AREA DESIGNATION PLAN

TECHNICAL DATA SHEET - PETITION #2001-90

**JOSEPHS PROPERTY**  
CITY OF CHARLOTTE E.T.I., NORTH CAROLINA

**SUBJECT:** Administrative Approval for Petition No. 2001-90 by Pulte Homes.

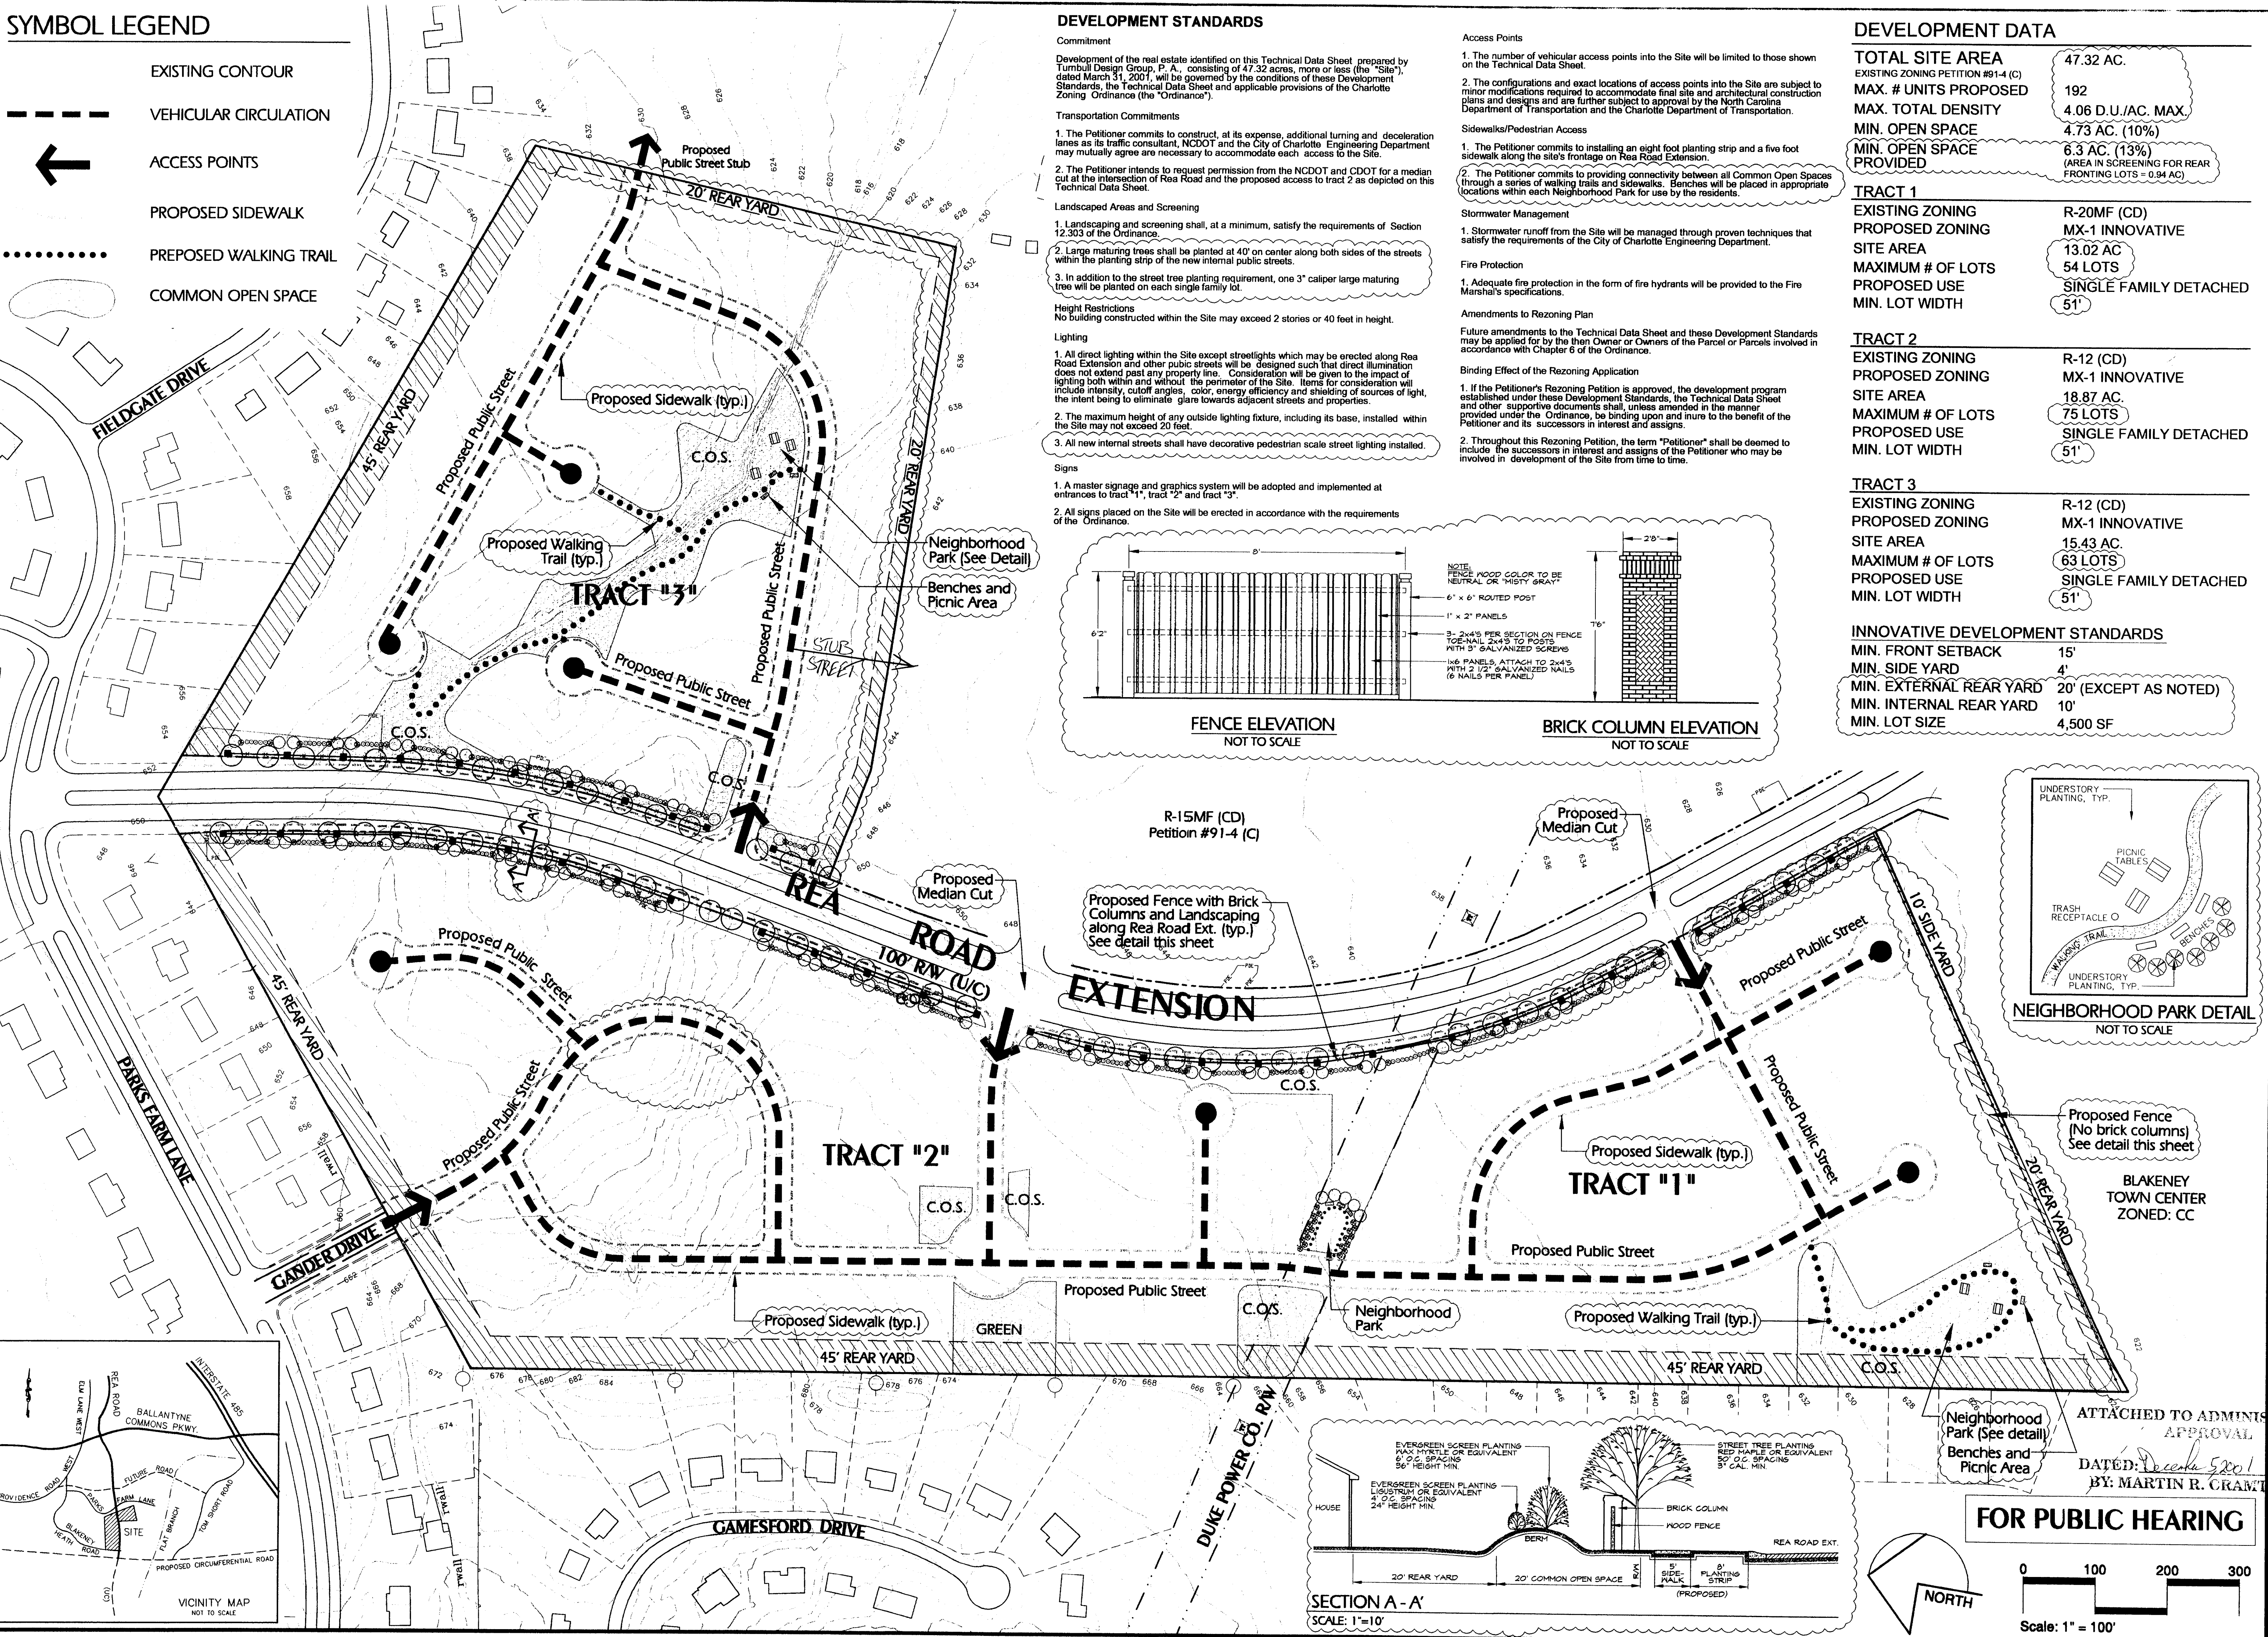
Attached is a revised technical data sheet for the above petition. The plan has been revised to show a relocation of access points, a shift in the common open space and a shift of one lot from tract 3 to tract 2. Since these changes are minor and do not alter the intent of the plan I am administratively approving this revised technical data sheet. Please use this plan when evaluating requests for building permits and certificates of occupancy.
